# MIAMI BEACH

### Staff Report & Recommendation

### Design Review Board

SUBJECT: DRB18-0333  
**5500 Collins Avenue – Towerhouse Condominium**

Details of typical floor plan from original plans, Permit 88131

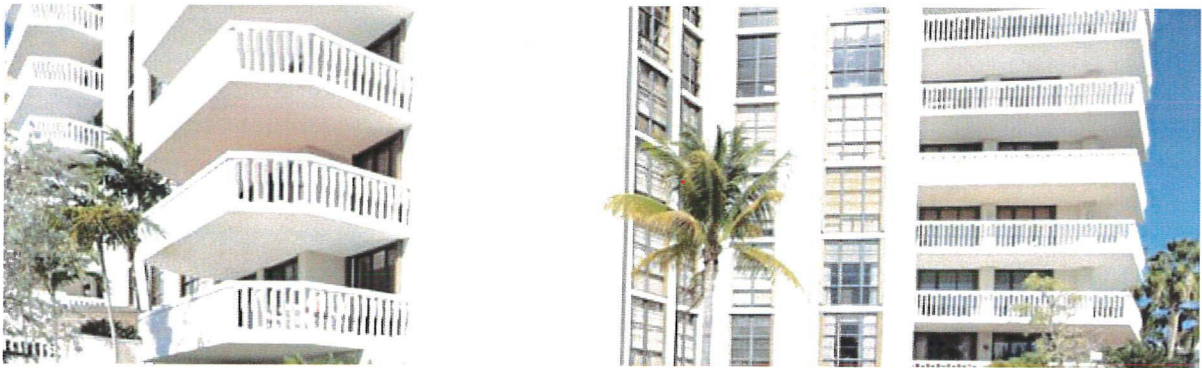
The original design for the Reiff-Fellman building contained precast concrete balusters with a tapered fin design that reflect the shape of the building. The pre-cast railings are a character defining element of the building's architecture. Nevertheless, the removal of decorative concrete, brise soleil and other solid masonry railing systems for the replacement of full glass railings along waterfront facing frontages, has been proposed in the past.

The proposal herein will allow for uniform views of the Indian Creek waterway and the northern and southern vistas of Collins Avenue, and create a consistent glass railing system that lightens the load on the balconies for added structural integrity. The original design does not feature balconies facing the east, likely due to the existence of the expansive Castle Beach Condominium built in 1964 that broadsides Collins Avenue and effectively blocks all views of the ocean. The total amount of demolition of concrete balconies is minimal in relation to the linear amount of balconies - which are already substantially transparent. Since the majority of the concrete fins on the balconies occur on less visible side elevations, the north and south, the noticeable effect on the architectural integrity of the building, as viewed from the street, will be minimal.

Consequently, staff does not object to the removal of the precast concrete portions of the balcony walls and the installation of the full glass railing replacement on all of the 84 balconies of the building and recommends approval of the application as proposed.
